HIGHLAND CITY DEVELOPMENT ADMINISTRATION BOARD AGENDA

DEVELOPMENT ADMINISTRATION BOARD AGENDA REPORT ITEM #1

DATE: October 10, 2024
TO: Development Administration Board
FROM: Rob Patterson, City Attorney / Planning & Zoning Administrator
SUBJECT: **Final Plat Approval:** Foxwood Estates
TYPE: **LAND USE (ADMINISTRATIVE)**

ATTACHMENT 6

Scale: 1"=20'	Drawn: GIM
Date: 09/09/24	Job #: 24-0002
Sheet:	
C4.2

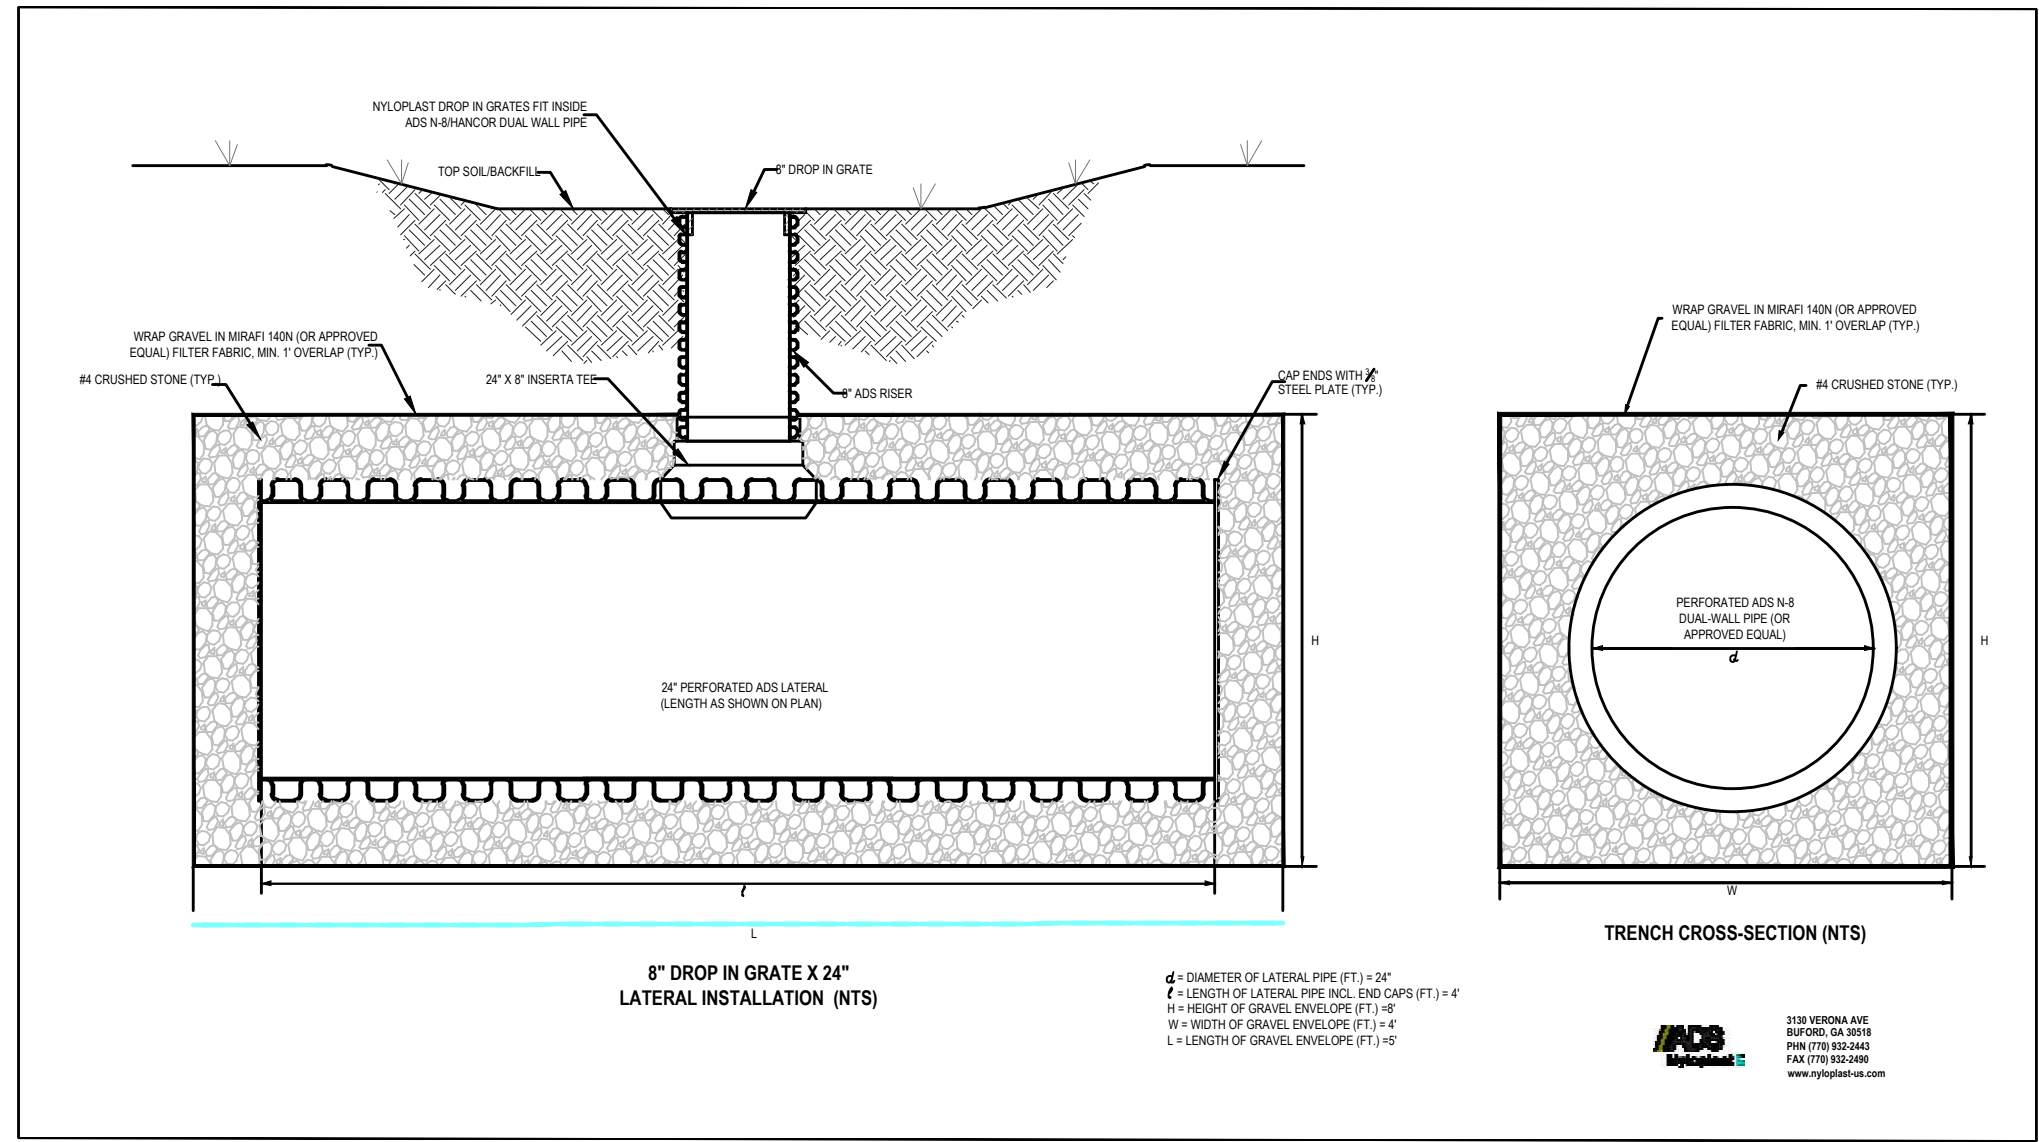
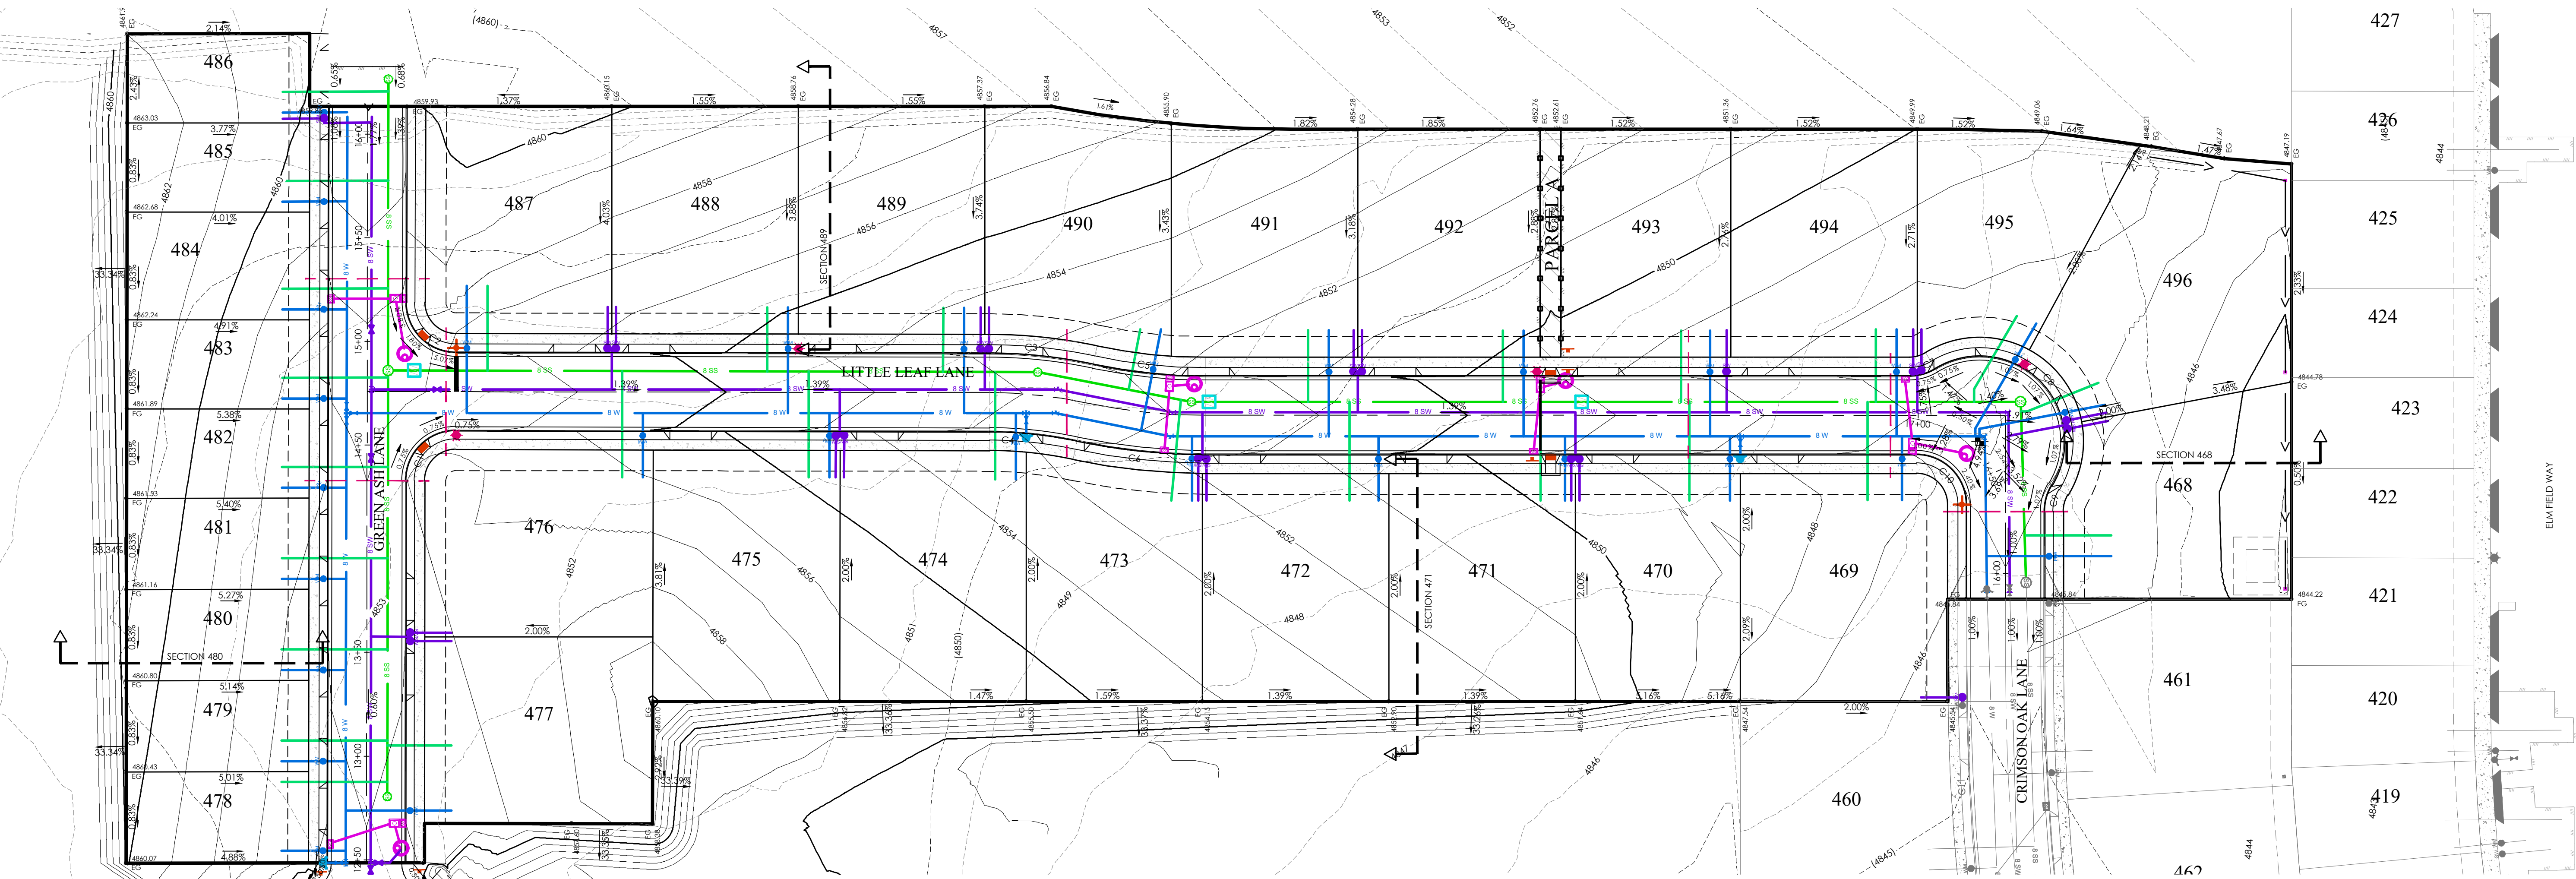
1. Temporary Turnaround: Symbol for 'No Parking Signs' added to sheet, but no details/spec/instructions provided. Provide enough detailed information so item can be approved by staff and built by contractor.
2. Crosswalk: Crosswalk shown, but no details/spec/instructions provided. Provide enough detailed information so item can be approved by staff and built by contractor.
3. Sumps: Storm drain report, Sheets C4-C4.2 (Grading and Drainage Plan):
APPLICANT RESPONSE IN GREEN (review comment #22):

- b. Revise the detail so it is readable, legible, and show what is to be built. Also, the calculations provided in the appendix of the drainage report for the rear yard sump do not share the same dimensions as the detail. Please revise.

-New response: The sump detail in the drainage report was revised and does match the detail included in the plan set.

-New response: There are two different sumps which are street sump and rear lot sumps. We added both to the drainage report and the rear lot sumps are shown on sheet C4.3.
